## SERVICE INFORMATION NO. SI 20-081

Rotax Service Bulletin No. SB-912-071 Replacement of oil filter

# Replacement of oil filter for ROTAX® Engine Type 912 i, 912 and 914 (Series)

Fig. 1  
Oil filter

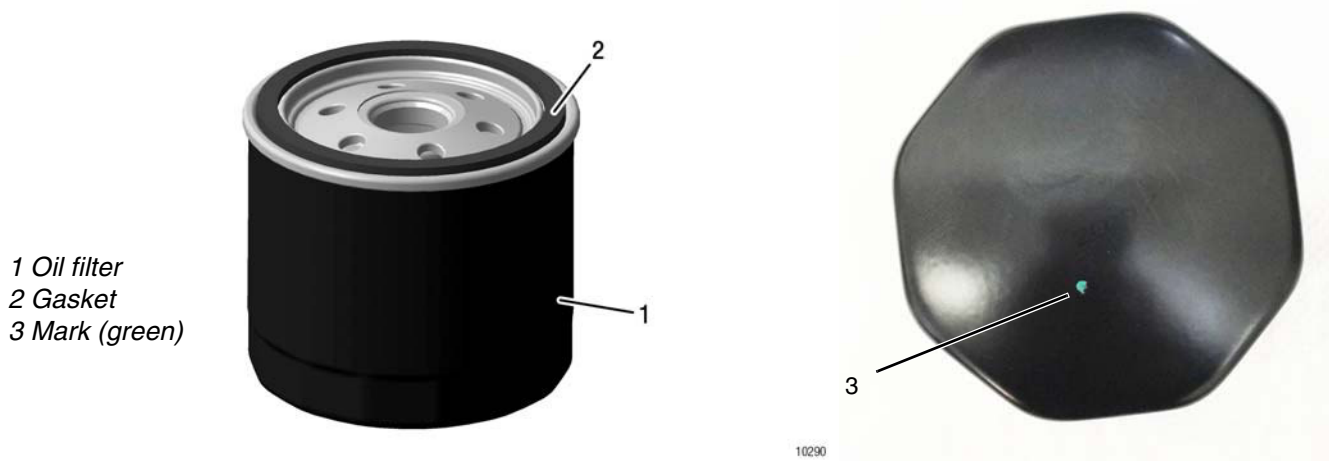
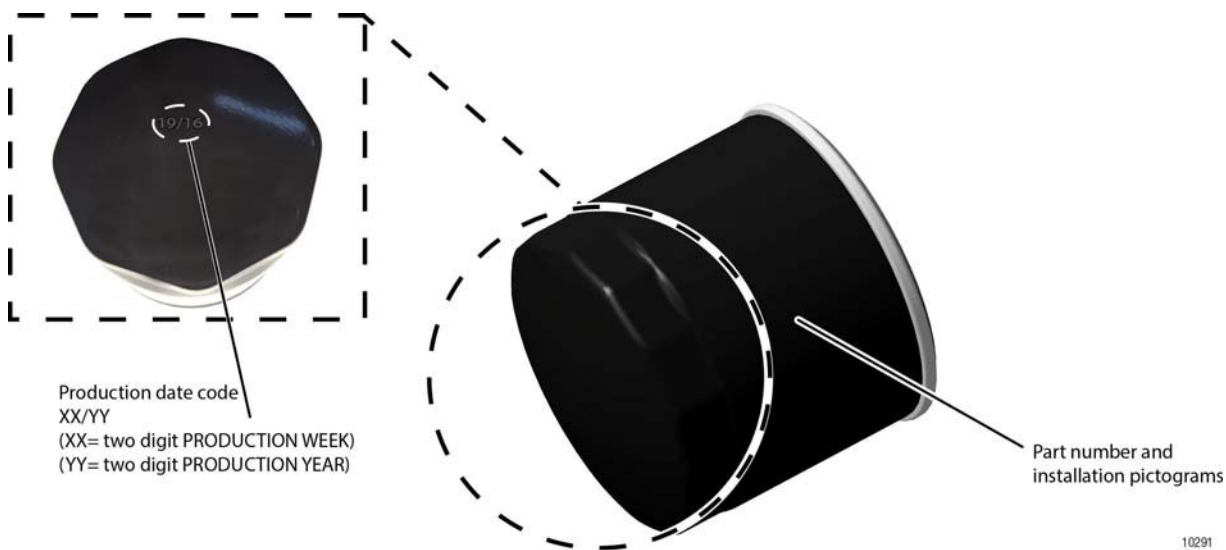
The above engines have been fitted by the manufacturer with an oil filter part no. 825016 with a production date code 10/17 up to 38/17 and have no green mark see Fig. 1).

All engines are affected, which have been equipped with an oil filter part no. 825016 (with a production date code from 10/17 up to 38/17) during engine repair, maintenance or general overhaul as of June 8<sup>th</sup>, 2017 to October 31<sup>st</sup>, 2017 and have no green mark. see Fig. 1).

Step	Procedure
1	Check the engine logbook and maintenance documentation or shipping documents to see if this Service Bulletin has already been accomplished.
2	<p>Check whether the affected oil filter shows a green mark on the crown of oil filter (as illustrated in Fig. 1) (same area as production date code).</p> <ul style="list-style-type: none"> <li>- green mark is present: this oil filter is OK as it has already been tested by the supplier and can be used even though the production date code is from 10/17 to 38/17. No further actions are required.</li> <li>- green mark NOT present: this oil filter is NOT OK, please follow the instructions in section 3.2).</li> </ul> <p>NOTE: If production date code is not easy to read, use a proper means of light (e.g. flashlight directed at a proper angle onto the oil filter crown etc.) for better visibility of the coding imprint.</p>

Step	Procedure
1	Remove the affected oil filter according to the Maintenance Manual Line.
2	Install the new oil filter according to the Maintenance Manual Line.

Step	Procedure
1	Quarantine and/or remove affected filters from your inventory. Mark as unserviceable and return F.O.B. to your ROTAX® Authorized Distributor or their independent Service Centers.
